# RS8234

Product and Documentation Errata

**Documentation Affected:** RS8234 Data Sheet (28234-DSH-001-B)  
**Product Affected:** RS8234EBGD (28234-15), RS8234EBGC (28234-13),  
RS8234EBGB (28234-12), and RS8234EBG (28234-11)

Figure 1-10. 2 ATM Network Elements (NE) Connected Full Duplex; NE A & NE B

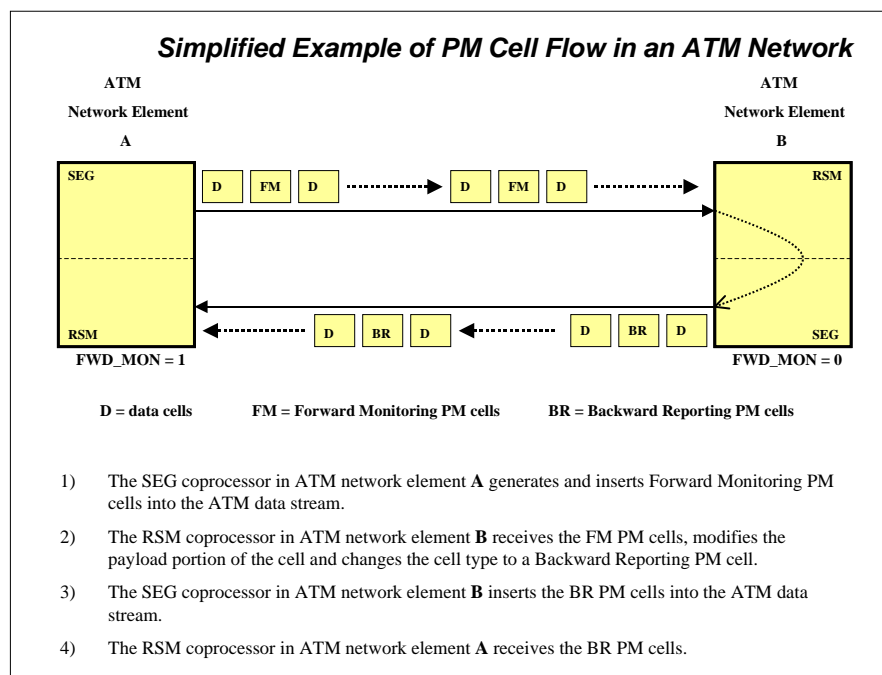
When the PM function is “re-enabled” on an active VCC with Forward Monitoring enabled, the SAR may generate an erroneous BR PM cell. The following figure and subsequent steps, show the test scenario in which this problem was uncovered.

The generation of the erroneous BR PM cell occurs in operation number 10 above. NE B was previously enabled for PM activity and had received a Forward Monitoring (FM) PM cell during operation number 3. Also during operation number 3, NE B turned around the received FM PM cell and sourced a BR PM cell to NE A. As part of the FM PM to BR PM cell processing in NE B, the SAR had set two state variables (ACK\_PM & BCK\_PM) in the SEG VCC table. When NE B sources a packet in operation number 6, with PM turned off, the SAR resets the ACK\_PM bit, but does not reset the BCK\_PM bit. When PM is re-enabled on NE B the FM PM to BR PM mechanism in the SAR is out of synchronization. The next packet segmented by NE B results in an erroneous BR PM cell being sent before the first data cell of the packet. After the generation of the erroneous BR PM cell in NE B, the SAR FM PM to BR PM cell processing mechanism is resynchronized. In this scenario NE A would receive an unexpected BR PM cell.

Two possible workarounds are available for this errata item. The first workaround accepts the possibility of an erroneous BR PM cell generation with S/W awareness. The second workaround eliminates the generation of the erroneous BR PM cell by setting two state variable bits in the SEG VCC table to an initialization state.

1. An awareness of this anomaly needs to be built into the application/driver S/W. All of the expected FM PM and BR PM cells are sent and received and the contents and Status indications are correct. The generation of the erroneous BR PM cell does not cause any corruption within the normal PM cell processing, it merely shows up as an unexpected BR PM cell at the receiving ATM Network Element. When this happens simply discard this cell.

2. The SEG VCC needs to be in an idle state (not actively segmenting) when performing writes to the SEG VCC Table in order to avoid potential coherency problems within bytes lanes. The ACK\_PM (bit 23 of word 0) and the BCK\_PM (bit 30 of word 6) control bits in the SEG VCC Table need to be set to zero when re-enabling the PM function on the VCC with Forward Monitoring. This will eliminate the possible generation of an erroneous BR PM cell .
